SONGS 1

Southern California Edison Company  <b>INTERIM CALCULATION CHANGE NOTICE (ICCN)                  CALCULATION CHANGE NOTICE (CCN)</b>	ICCN NO./PRELIMINARY CCN NO.		CCN CONVERSION :		CALC. REV. 5	
	CALCULATION NO. DC-2836		CCN NO. CCN- C-1	REV. 4	UNIT. 1	
	CALCULATION TITLE : SONGS-1 HYDRAULIC CALC. FOR AFW LINES - FLOW REQUIREMENTS					
	ORIGINATOR Sharok Khabir			SYS. NO/STAT. SYS. DESIGNATOR AFW		
	PAX 51319	DATE 8-6-90		PAGE 1 OF 1

REVISE CALC. DC-2836 TO INCLUDE ADDITIONAL SUPPLEMENT C. (ATTACHED.)

SONGS Unit 1 DCP/MMP No. & Rev. 1-3587.0ISM Calc. No. DC-2836  
 Subject AFW FLOW REQUIREMENT VERIFICATION  
 Engineering System Number \_\_\_\_\_ Primary Station System Designator AFW Q-Class SR  
 Tech Spec Effecting  YES  NO Section No. 3.4.3 Equipment Tag No. \_\_\_\_\_

OUTLINE DRAWING  
3" CAVITATING VENTURI  
AUX. FEEDWATER SYSTEM

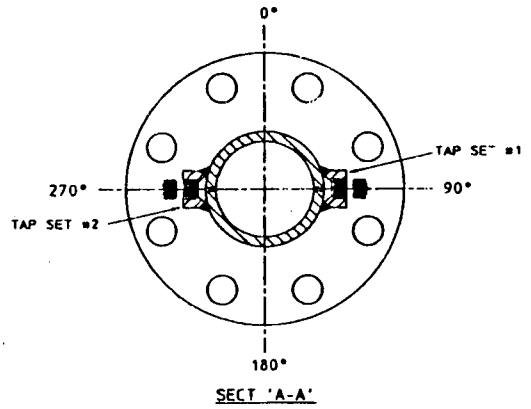
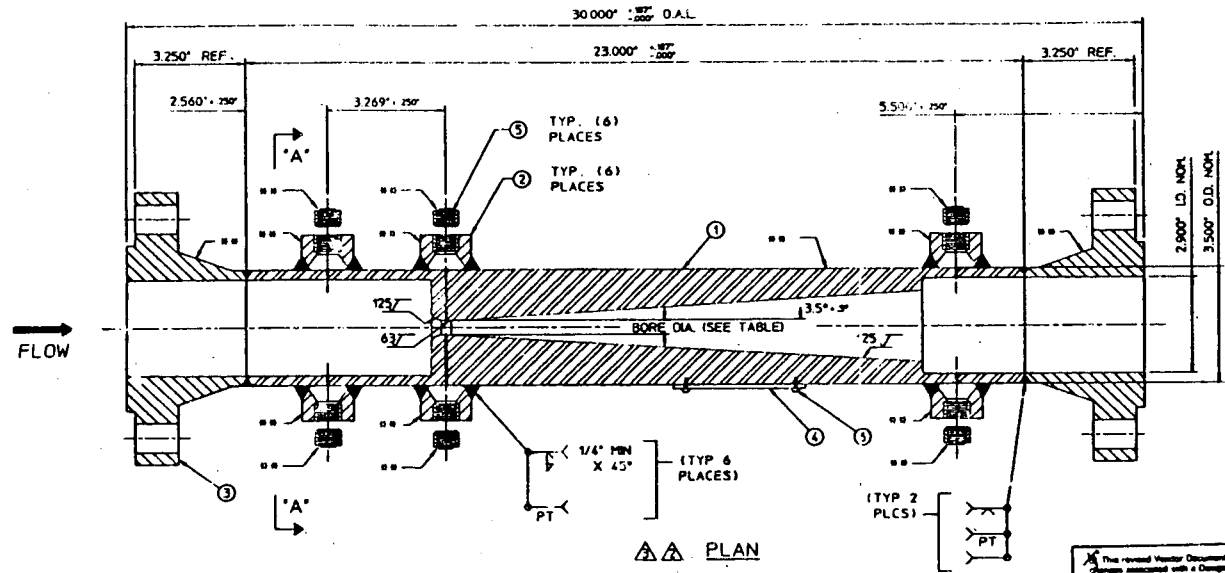
REV	BY	DATE	REVISIONS	REV	BY	DATE	REVISIONS
1	JVP	5-23-90	ADDED NOTE # 1, NCS 5-23-90, LCP 5-23-90.				
2	JVP	5-29-90	REVISED PLAN VIEW, NCS 5-30-90, LCP 6-1-90.				
3	JVP	6-6-90	RESTORED VENTURI BODY (ITEM 1) TO ONE-PIECE DESIGN, REVISED PLAN VIEW, NCS 6/6/90, LCP 6/6/90.
